Geneva, 25-28 September 2018 Item 6 (d) of the provisional agenda Autonomous/automated and connected vehicles: Automatically Commanded Steering Function

Proposal for a Supplement to UN Regulation No. 79 (Steering Equipment)

Submitted by the experts from the International Organization of Motor Vehicle Manufacturers and European Association of Automotive Suppliers**

Figure 1

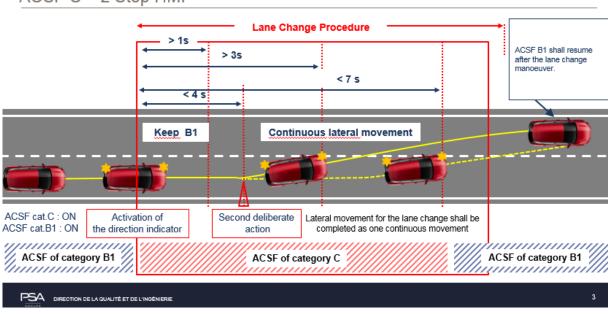
- 4. The lane change function with two-step HMI is a quite natural HMI, closer to manual lane change: the driver has full control on the timing of the two steps of a lane change, i.e. initiating the lane change procedure, then initiating the lateral movement, by two deliberate actions.

- 5. This permits an increase in the maximum time between the Lane Change Procedure and the Lane Change Manoeuvre.
- 6. So, it is proposed to initiate the lateral movement of the vehicle after the second deliberate action.

- 7. This second action shall be performed at the latest 4 seconds after the start of the lane change procedure. The lane change manoeuvre shall be initiated at the latest seven seconds after the initiation of the lane change procedure.
